## HISTORIC AND DESIGN REVIEW COMMISSION

February 07, 2018

**HDRC CASE NO:** 2018-066  
**ADDRESS:** 407 CEDAR ST  
**LEGAL DESCRIPTION:** NCB 2968 BLK 3 LOT 2  
**ZONING:** RM-4, H  
**CITY COUNCIL DIST.:** 1  
**DISTRICT:** King William Historic District  
**APPLICANT:** Fernando Morales/Candid Rogers Architect, LLC  
**OWNER:** James & Pamela Duerr  
**TYPE OF WORK:** Construction of a rear addition  
**APPLICATION RECEIVED:** January 17, 2018  
**60-DAY REVIEW:** March 18, 2018  
**REQUEST:**

**1 EAST ELEVATION**  
Scale: 1/8"=1'-0" @ GARAGE/SHED

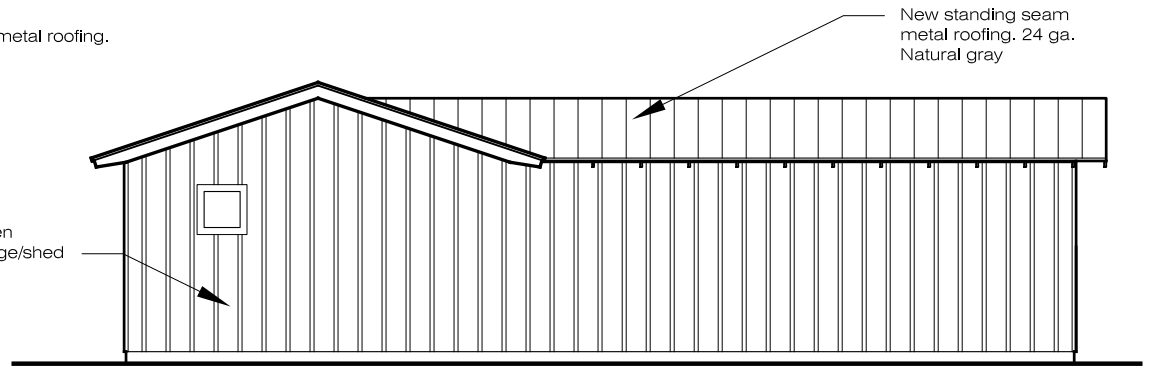
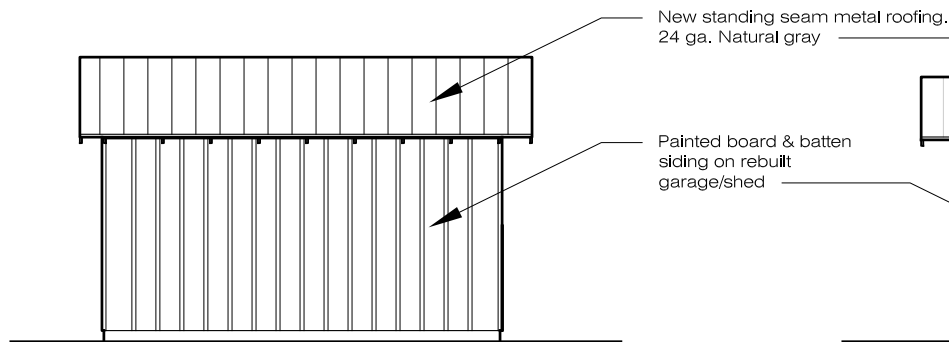
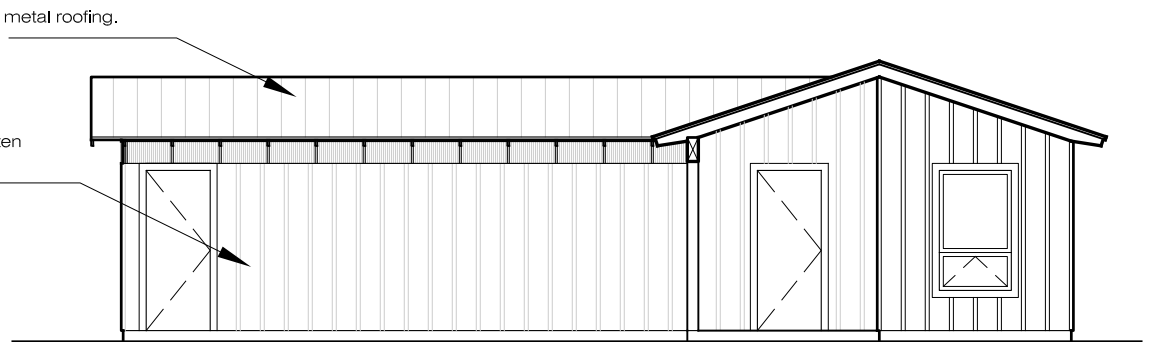
- j. **ACCESSORY STRUCTURE** – The applicant has proposed to reconstruct the rear, accessory structure to match its existing profile. Staff finds the proposed reconstruction of the rear accessory structure to be appropriate and consistent with the Guidelines. The proposed standing seam metal roof should feature panels that are 18 to 21 inches wide, seams that are 1 to 2 inches in height, a crimped ridge seam and a standard galvalume finish. The applicant is to submit the proposed new garage door to staff for review and approval. Staff recommends a wood door.

- i. That the proposed standing seam metal roof feature panels that are 18 to 21 inches wide, seams that are 1 to 2 inches in height, a crimped ridge seam and a standard galvalume finish.
- ii. That a wood garage door be installed.
